SUBJECT: TRIP REPORT: NRC REVIEW OF GEOPHYSICAL DATA FOR THE  
PARADOX BASIN

NRC DATA REVIEW OF GEOPHYSICAL DATA FOR THE PARADOX BASIN  
16 to 18 October, 1984  
Woodward-Clyde Consultant office  
San Francisco, CA

### GEOLOGY-GEOPHYSICAL DATA REVIEW CHECKLIST

WOODWARD-~~Y~~YDE  
 PARADOX BASIN  
 SAN JUAN CO., UTAH

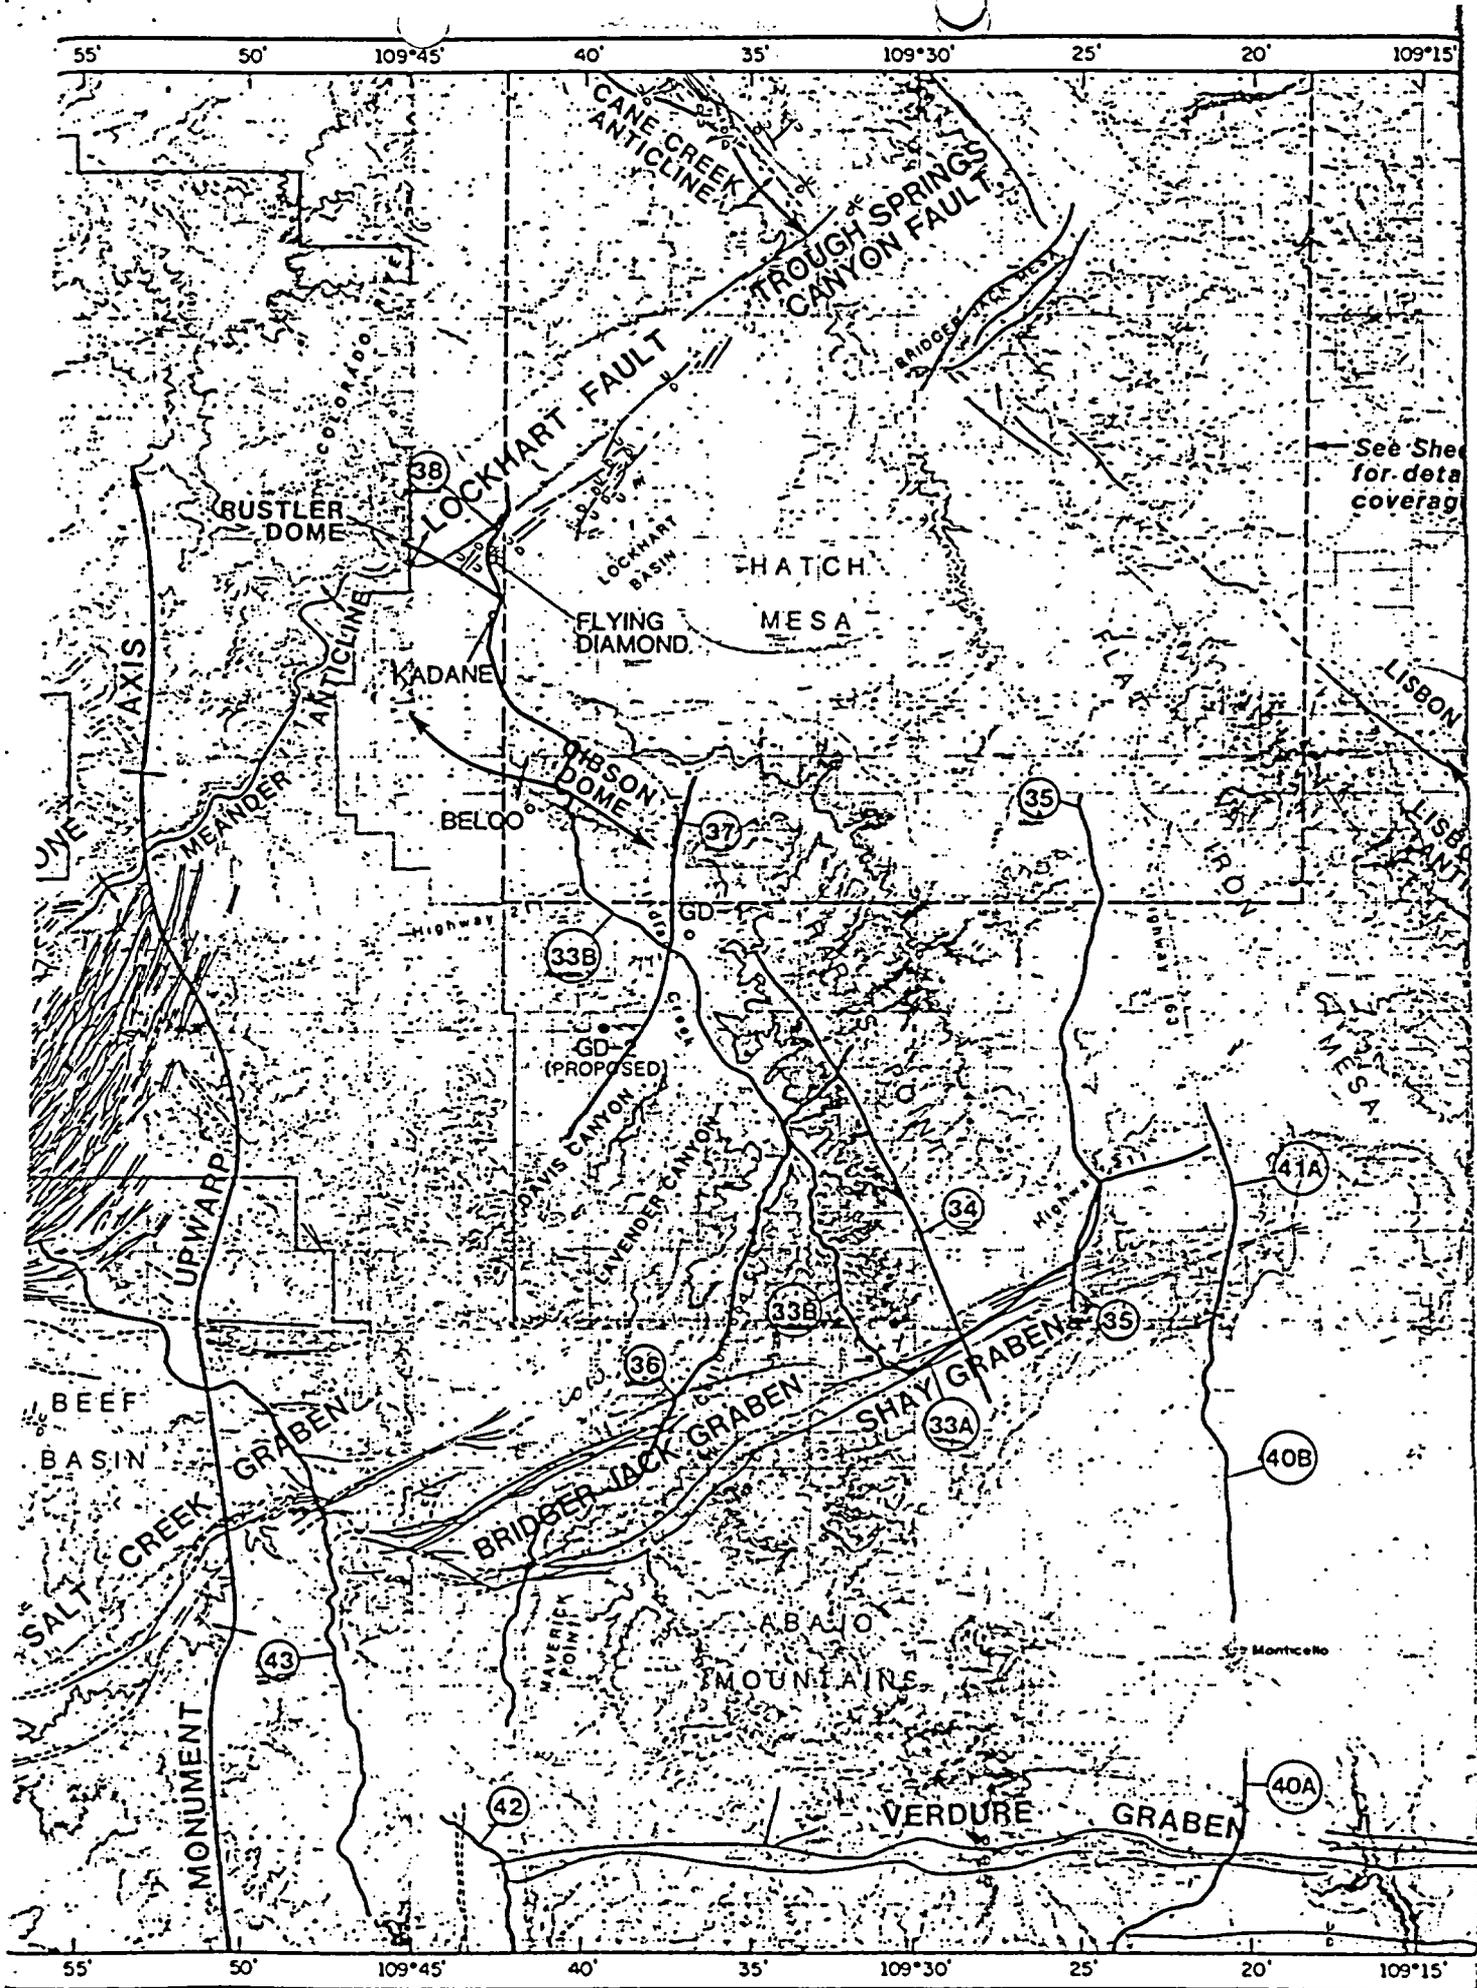
PROCESSING PROCEDURE IN SEG-B FORMAT AS SHOWN ON ATTACHED HEADER SHEET EXAMPLE.

*NORMAL DATA PROCESSING USED. SEE ATTACHED HEADER SHEET  
EXAMPLE FROM LINE 37 DAVIS CANYON AREA.*
